Work Order ID 145830

Item Name: Replacement Skidtube, High Gear with Standard Wearplates Fits LH or RH

DRAWING NO. D2650	TITLE 206/407 SKIDTUBE ASSEMBLIES	REV. F	DART AEROSPACE LTD ENGINEERING ORDER		D.E.O. NO. D2650-F-1	SHEET NO. SHEET 1 OF 1	SCALE NTS
DRAWN <i>[Signature]</i>	CHECKED <i>A.P.</i>	MFG. APPR. <i>[Signature]</i>	APPROVED <i>[Signature]</i>		DE APPR. <i>[Signature]</i>		
DATE 12.10.12	DATE 12.10.22	DATE 12.10.22	DATE 12.10.22		DATE 12.10.22

CHANGE C'BORED WELDED CROSSBOLT SPACERS TO SWAGED SPACERS

AMENDMENT TO DETAIL B
NOT TO SCALE

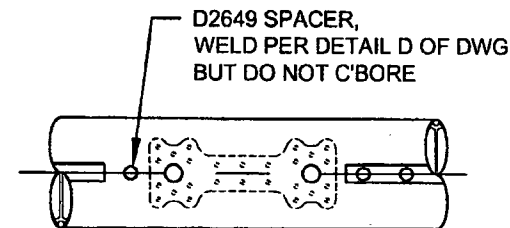
ADD DETAIL G BELOW, WHICH IS THE SAME SECTION VIEW AS DETAIL D OF DWG.

C'BORED HOLES ARE NOW SWAGED PER DETAIL G BELOW. FOR THE Ø0.375 HOLE THAT IS NOT C'BORED, WELD PER DETAIL D OF DWG (SEE AMENDED DETAIL B FOR REFERENCE).

DETAIL G

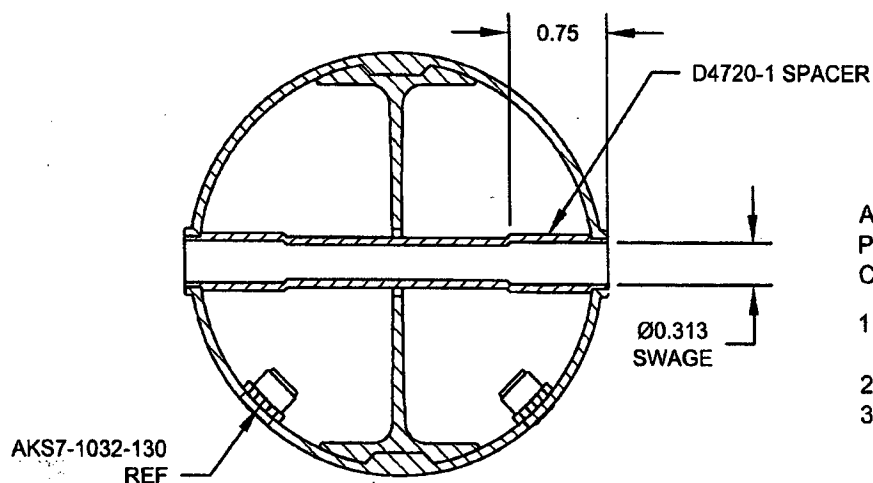
FOR HOLES THAT ARE CURRENTLY C'BORED ONLY
NOT TO SCALE

AFTER DRILLING AND BENDING ASSEMBLY
PERFORM THE FOLLOWING FOR Ø0.375 HOLES THAT ARE
CURRENTLY C'BORED:

1. INSERT D4720-1 SPACER, 16 PL (-1) OR 17 PL (-3)
OR 19 PL (-5) OR 23 PL (-7)
2. SWAGE TO Ø0.313 X 0.75 DP PER QSI 002
3. TRIM / GRIND FLUSH PER QSI 002
